Ref: PEG-1155-93M-CN-HI-BOA-LET-RS-11881
Jean Marc Decloquement
Consortium Director
Blocks 277-278,2nd business sector,
Teseen st, Shaker Consultancy Building
New Cairo, Egypt.

Project: Engineering, Procurement and Construction of the New Administrative Capital Monorail and 6th October City Monorail (Contract 93/Metro).

Subject: Comments on shop drawings. // 93M-BOA-NAT-LOT- 28937

Sec (R - R)
1:7.5

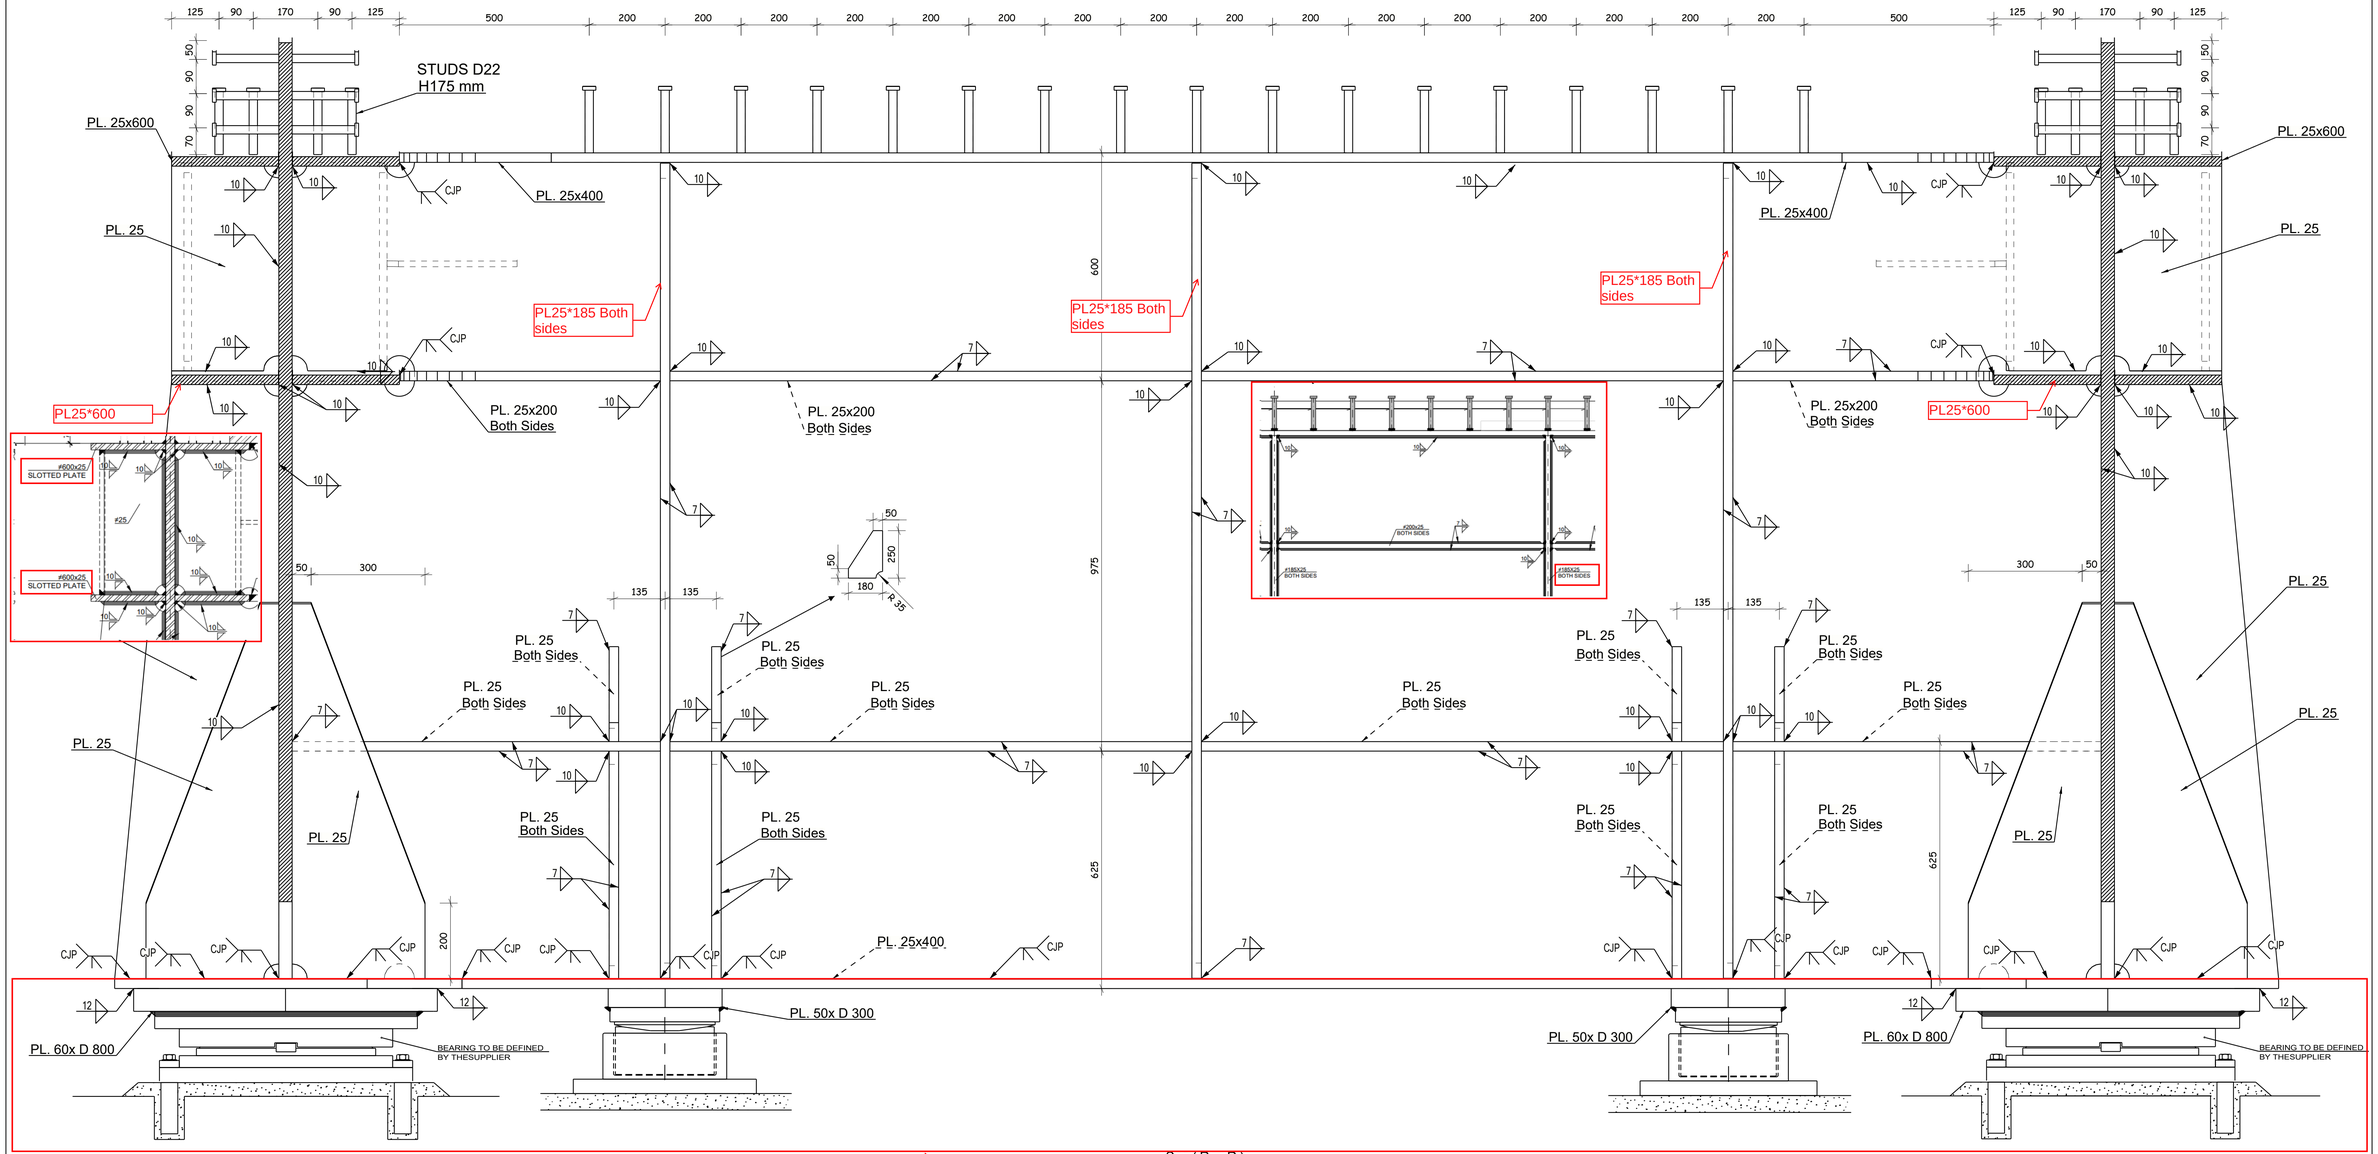
Bearings should be submitted to be revised and approved, before being supplied. Contractor is responsible for closing this comment.

Mark	Profile	Grade	QTY	Length	Area	Weight
1001	FLT25*400	S355J2N	4	800.0	0.41	34.9

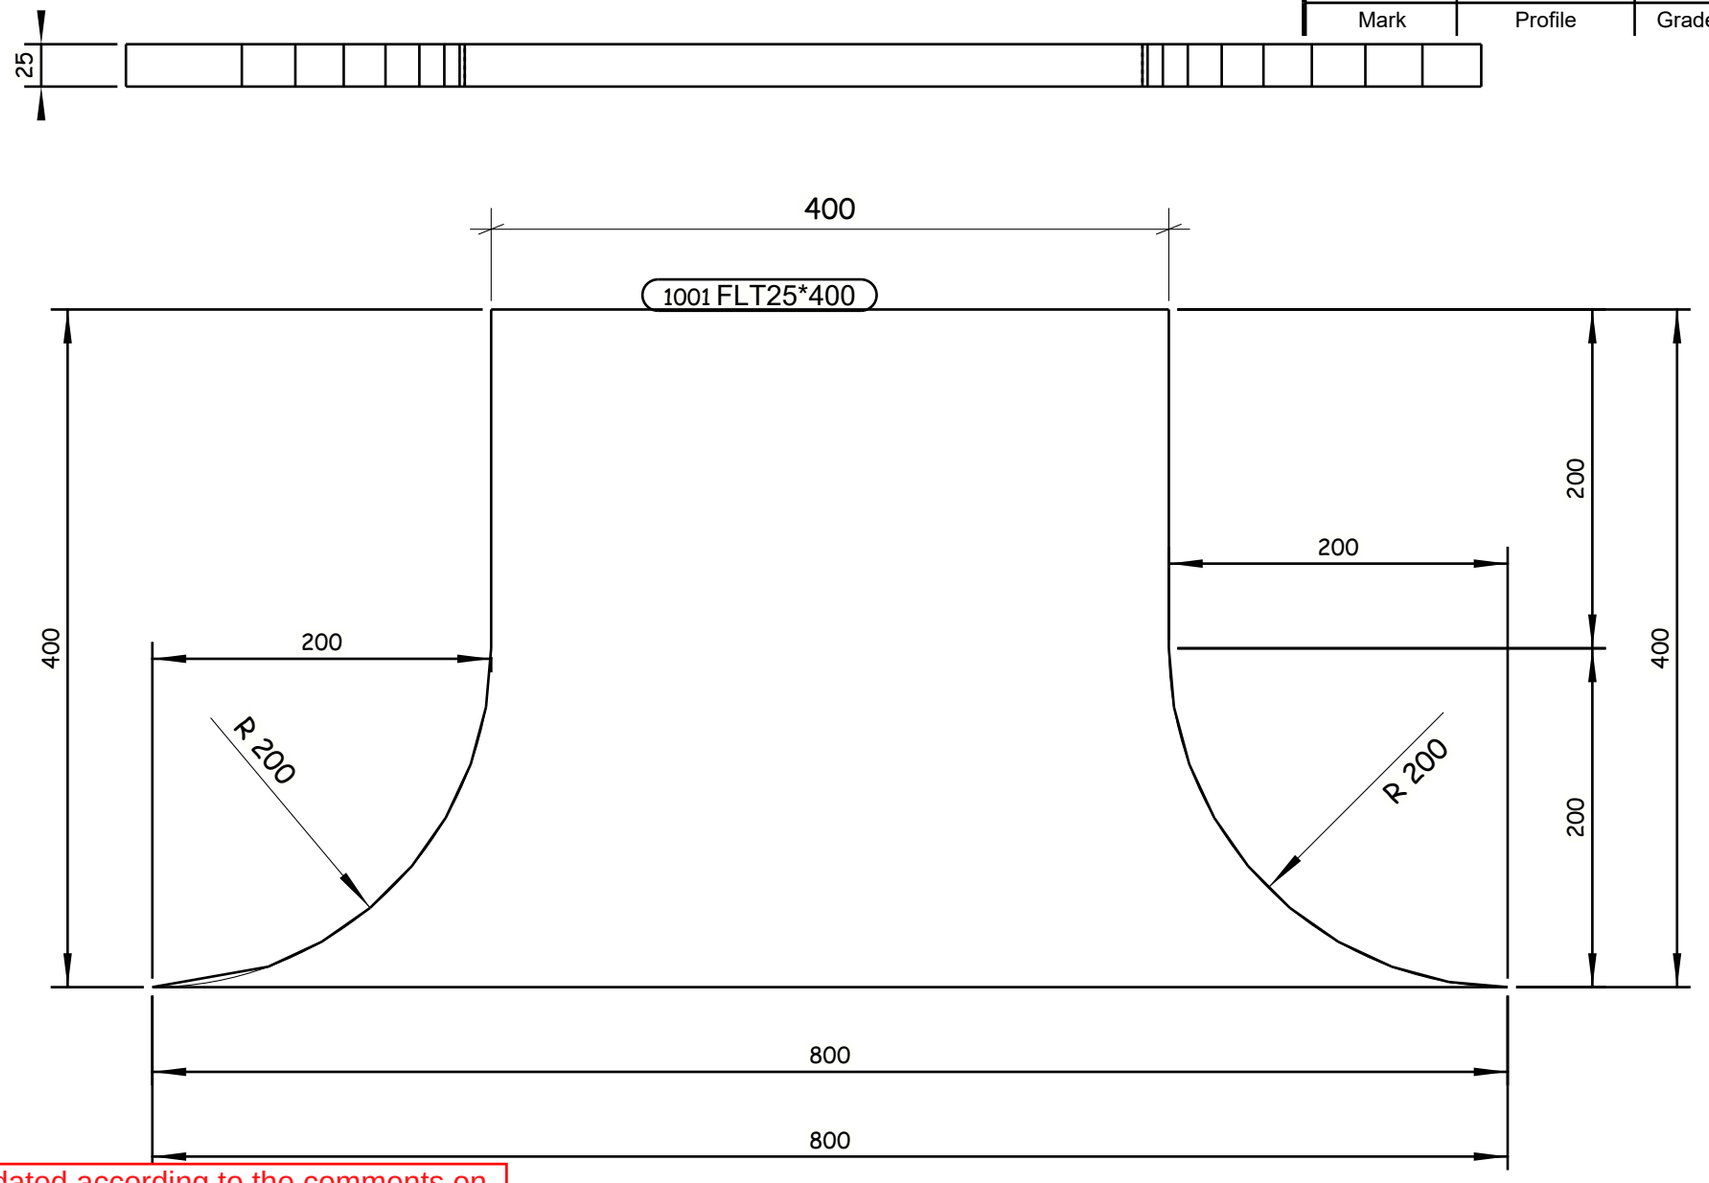
-Drawing shall be updated according to the comments on the GA drawing.
-Approval is subjected to the approval of coordination package between multi-discipline.

Mark	Profile	Grade	QTY	Length	Area	Weight
WP19	PL20*520	S355J2N	4	2572.5	2.80	209.8

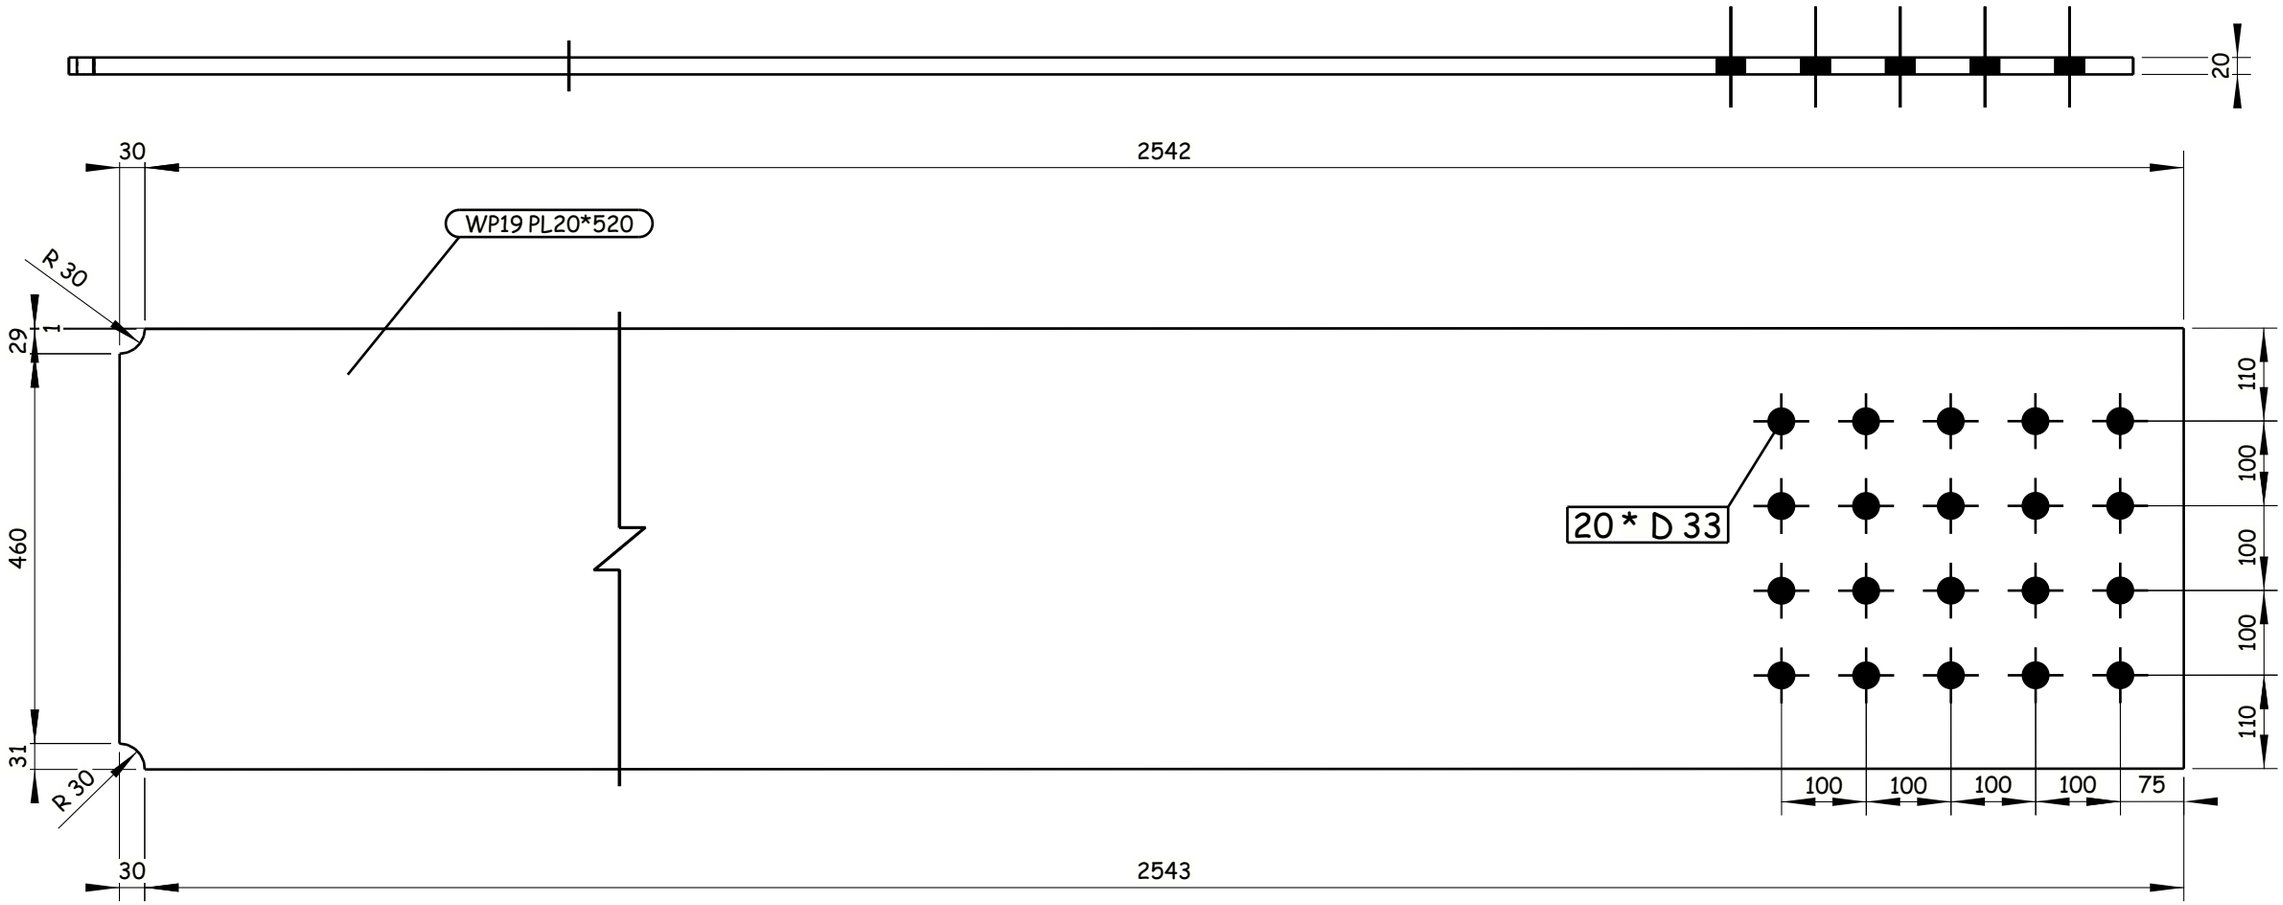
-Drawing shall be updated according to the comments on the GA drawing.
-Approval is subjected to the approval of coordination package between multi-discipline.
